MODIFICATION BULLETIN NO. IXO-001ISSUED ON July 23, 1993

Model	IXO					Date of Modification	
Modified Article						Execution Date	
Reason for Modification	<input checked="" type="checkbox"/> Parts catalog correction <input type="checkbox"/> To meet standards () <input type="checkbox"/> To facilitate assembly <input type="checkbox"/> Vender change <input type="checkbox"/> Part standardization <input type="checkbox"/> To improve reliability <input type="checkbox"/> Other						
Old Part No.	New Part No.	Description	Q'ty Used Old → New	Interchange- ability	Remarks	Parts Catalog	
						Index No.	Page
H5042146	H5042148	Decal - Release Lever	1 → 1			63	1-5
H504 2154	H504 2157	Seal - Guide	1 → 1			62	1-5
	H504 2131	Reinforcement Feed Roller	0 → 1			77	1-5
	H504 2155	Small Seal - Guide	0 → 2			78	1-5
	H504 3127	Spacer - Speaker	0 → 1			20	1-3
H.Motojima Assistant General Manager FTS Sect. TS Dept.

DETAILS OF MODIFICATION

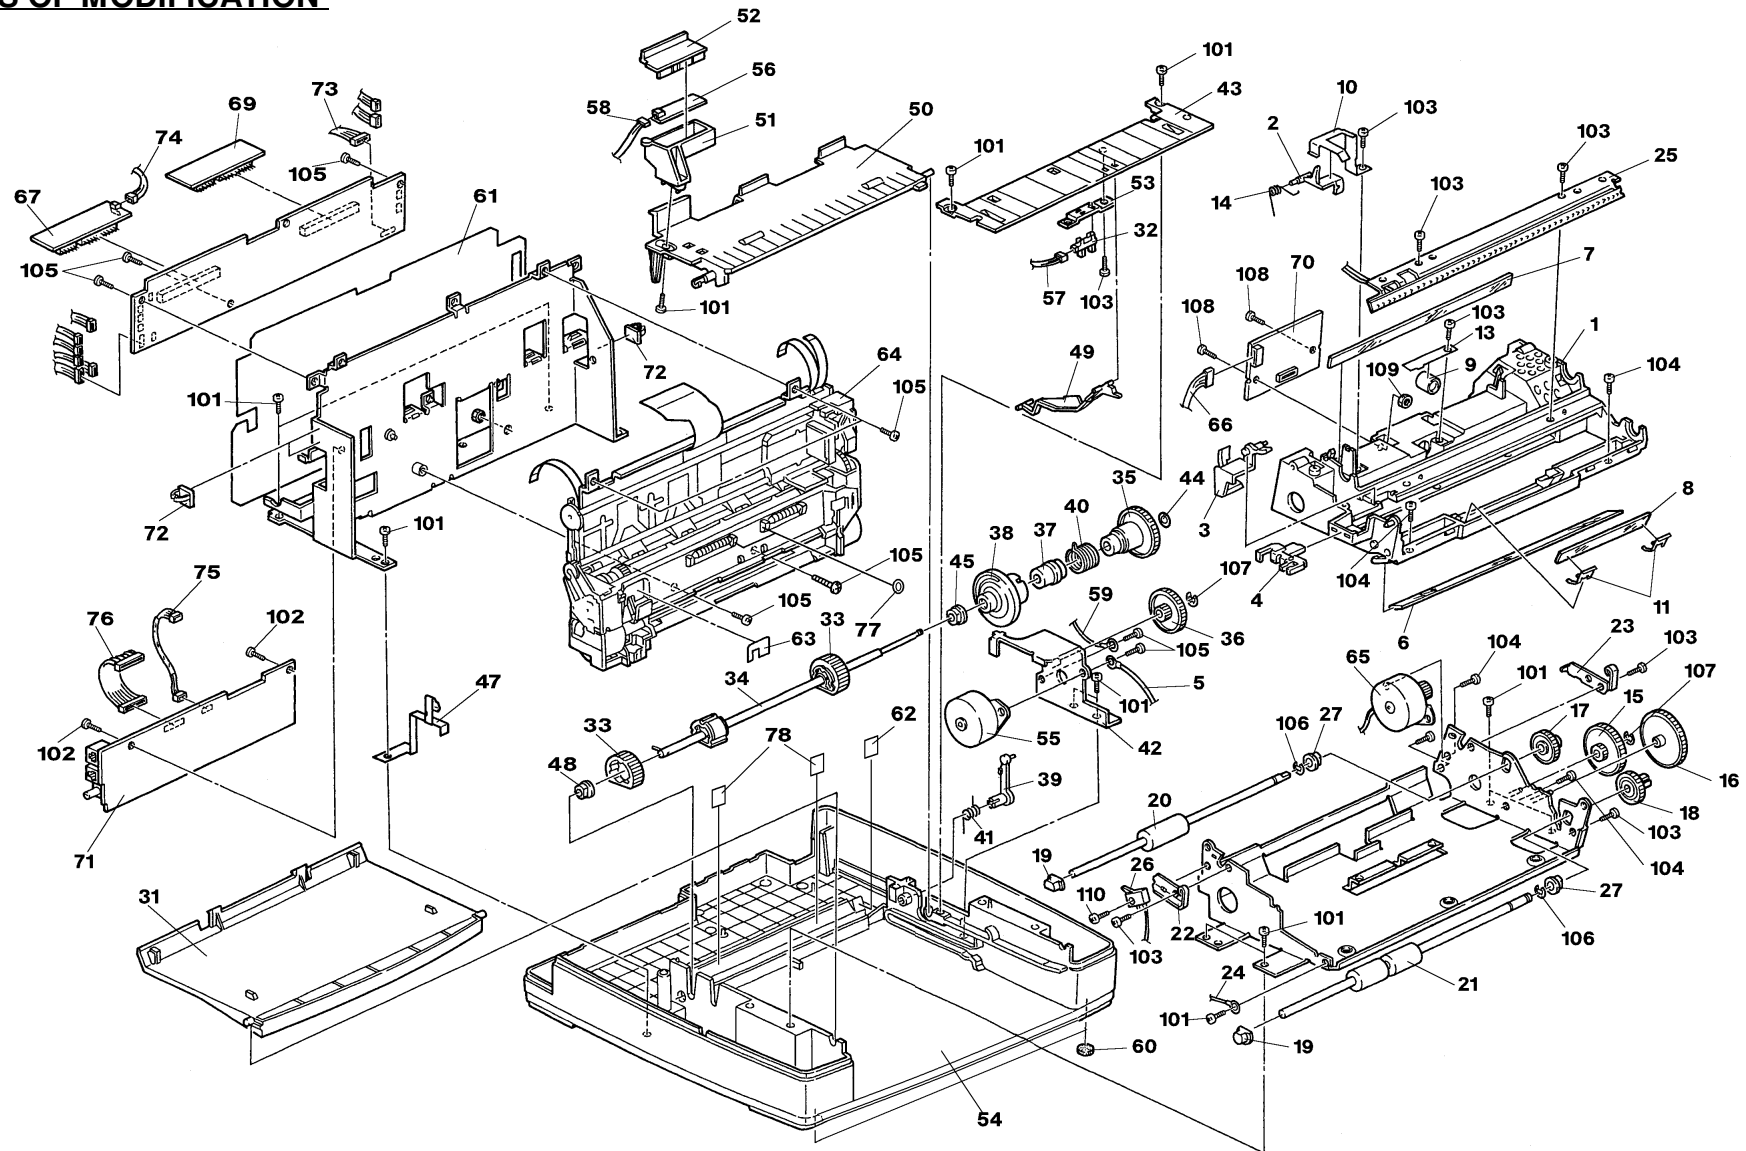
Model	IXO(Telautograph)						Date of Modification	
Modified Article	Base						Execution Date	
Reason for Modification	<input checked="" type="checkbox"/> Parts catalog correction <input type="checkbox"/> To meet standards () <input type="checkbox"/> To facilitate assembly <input type="checkbox"/> Vender change <input type="checkbox"/> Part standardization <input type="checkbox"/> To improve reliability <input type="checkbox"/> Other							
Old Part No.	New Part No.	Description	Q'ty Used Old → New	Interchange- ability	Remarks	Parts Catalog		
						Index No.	Page	
H504 3101	H504 3151	Base: TEL				54	1 - 5	
<div style="text-align: right;"> H.Motojima Assistant General Manager FTS Sect. TS Dept. </div>

DETAILS OF MODIFICATION

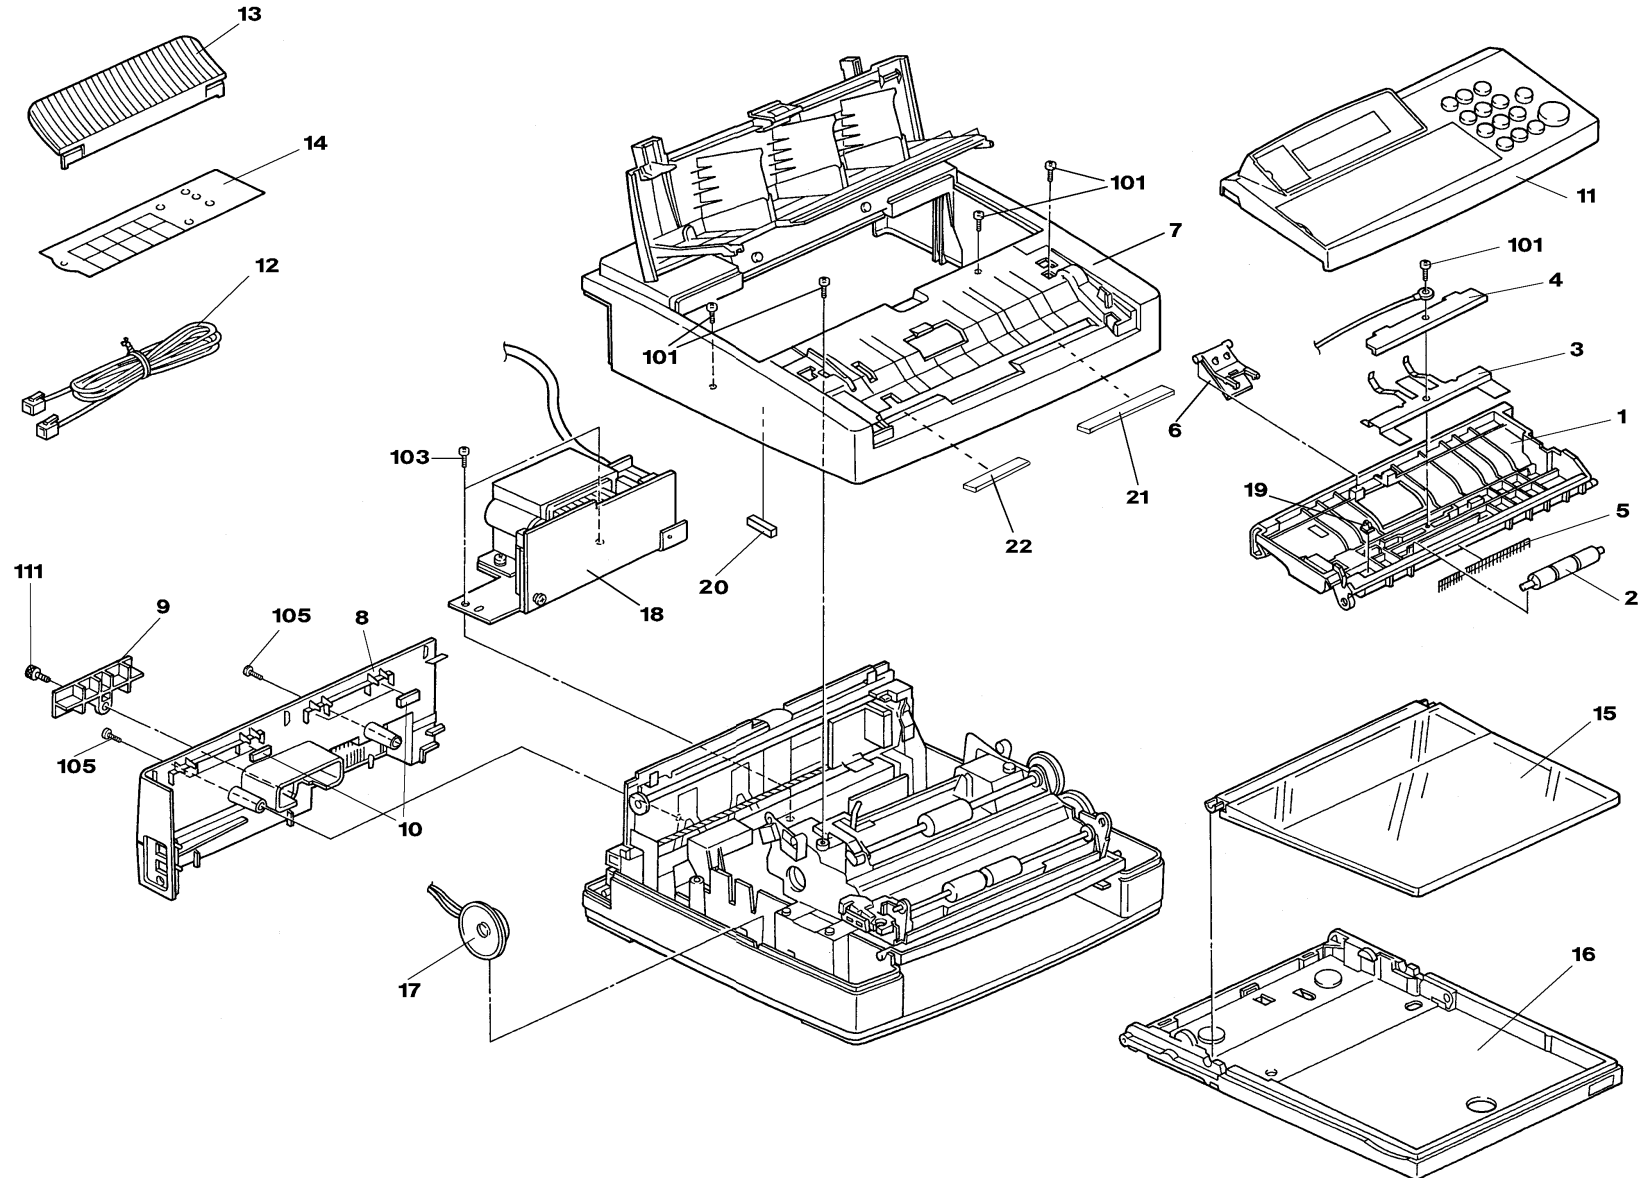
Model	IXO						Date of Modification	
Modified Article	Scanner						Execution Date	
Reason for Modification	<div> <input checked="" type="checkbox"/> Parts catalog correction <input type="checkbox"/> To meet standards () <input type="checkbox"/> To facilitate assembly </div> <div> <input type="checkbox"/> Vender change <input type="checkbox"/> Part standardization <input type="checkbox"/> To improve reliability </div> <div> <input type="checkbox"/> Other </div> <p>Please refer to the RTB IXO-010 when putting the spacers.</p>							
Old Part No.	New Part No.	Description	Q'ty Used Old → New	Interchange- ability	Remarks	Parts Catalog		
						Index No.	Page	
	H504 1105	Right Scanner Spacer	O → 1			21	1-3	
	H504 1106	Left Scanner Spacer	O → 1			22	1-3	
<div>S.Hamano</div> <div>Assistant General Manager</div> <div>Second Technical Support Section</div> <div>International Marketing Group</div>

DETAILS OF MODIFICATION

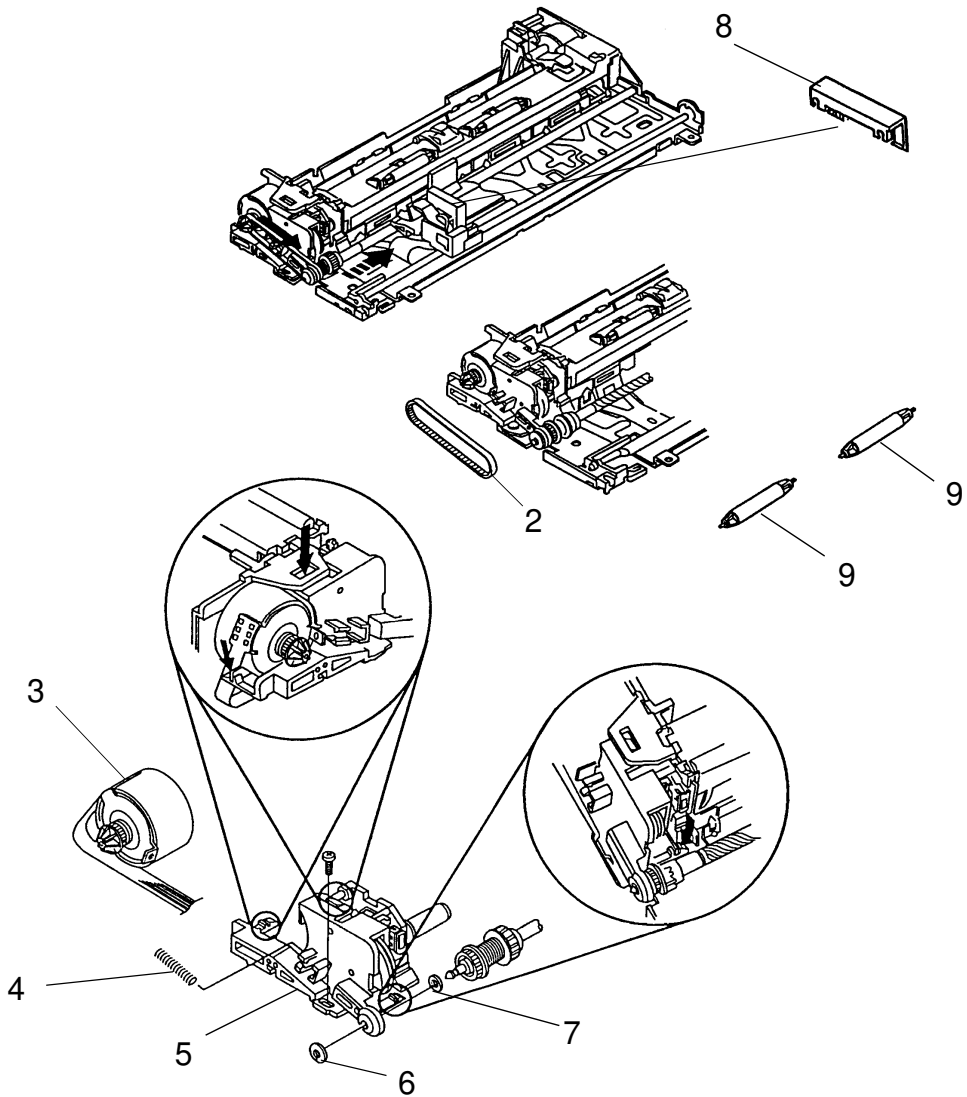
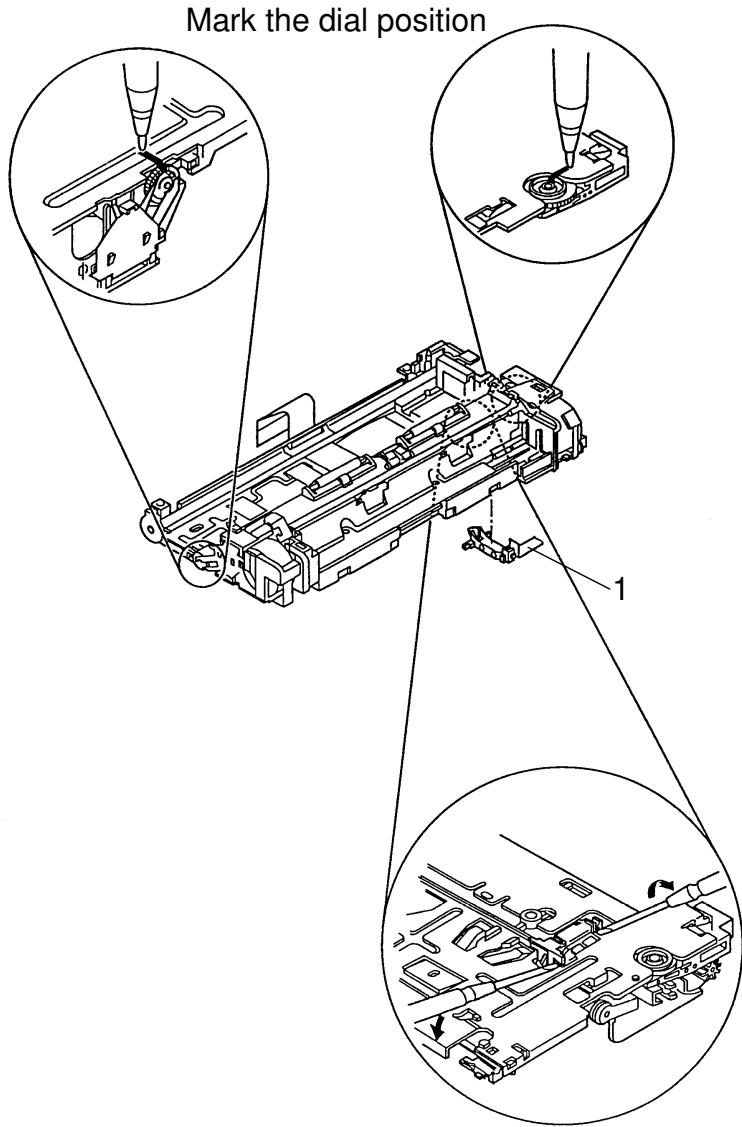
Model	IXO					Date of Modification	
Modified Article	TIJ Unit					Execution Date	
Reason for Modification	<input type="checkbox"/> Parts catalog correction <input type="checkbox"/> To meet standards () <input type="checkbox"/> To facilitate assembly <input type="checkbox"/> Vender change <input type="checkbox"/> Part standardization <input type="checkbox"/> To improve reliability <input checked="" type="checkbox"/> Other						
<p>To supply the following parts included in the TIJ unit as service parts, the following part numbers have been set up.</p>							
Old Part No.	New Part No.	Description	Q'ty Used Old → New	Interchange- ability	Remarks	Parts Catalog	
						Index No.	Page
	H5042510	Paper Sensor - TIJ	(0 → 1)			1	
	H5042511	Carriage Drive Belt - TIJ	(0 → 1)			2	
	H5042512	Carriage Motor - TIJ	(0 → 1)			3	
	H5042513	Belt Tension Spring - TIJ	(0 → 1)			4	
	H5042514	Purge Unit - TIJ	(0 → 1)			5	
	H5042515	Carriage Shaft Stopper - TIJ	(0 → 1)			6

H5042516	Slider - TIJ	(0 → 1)			7	
	H5042517	Ribbon Cable Holder - TIJ	(0 → 1)			8	
	H5042518	Eject Roller - TIJ	(0 → 2)			9	
<p style="text-align: right;">S.Hamano Assistant General Manager 2nd T.S.Sec. Int'l Marketing Group</p>
